SERVICE BULLETIN AR 3201 - 3/92

SUBJECT : Synthesizer Modules AR 3201

Synthesizer Module 28110 - 13000.000

Synthesizer Module 28141 - 13000.000

Fig. 1: Location of battery Bat. 3051 on Synthesizer Module 28110 - 13000.000

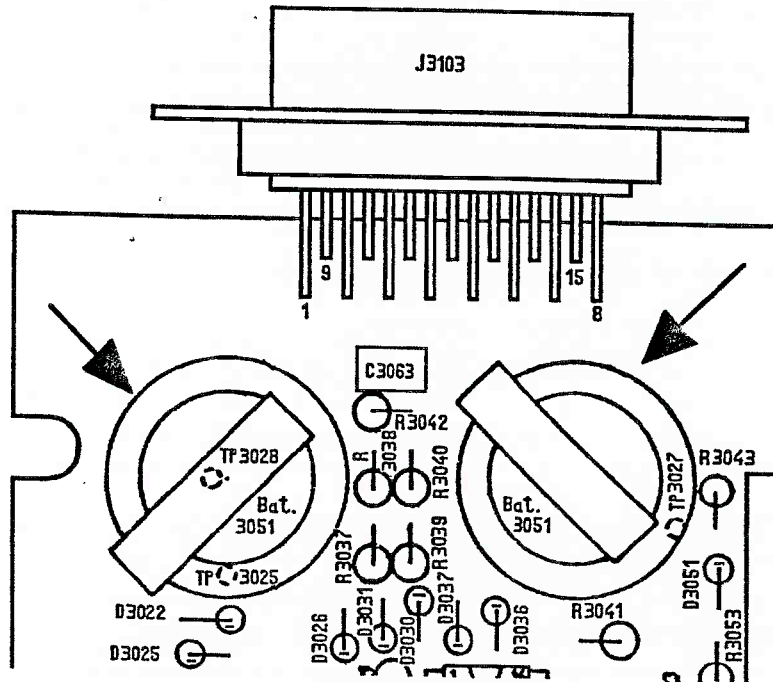
1. Determine manufacturing date of the Ni/Cd-battery. Since 1986 there is a marking on the battery's label (Bat. 3051 and Bat. 3052 or Bat 3001) which describes the manufacturing date.
For example : 8707 means manufacturing date: 7th calendar week 1987
2. If the batteries are more than 4 years old it is recommended to replace the batteries, even if there is no visible damage.
3. Carefully check the battery connectors and the surrounding components for sediments.
4. If there are any damages, remove the battery and surrounding components in order to get access to the contaminated printed conductors for cleaning. Use alcohol (methyl alcohol 94%) and a glass-brush for cleaning. Any component removed should be replaced with a new part.
5. If battery replacement is necessary, insert and solder new batteries as shown in Figures 1 to Figure 5. Ensure correct polarity!
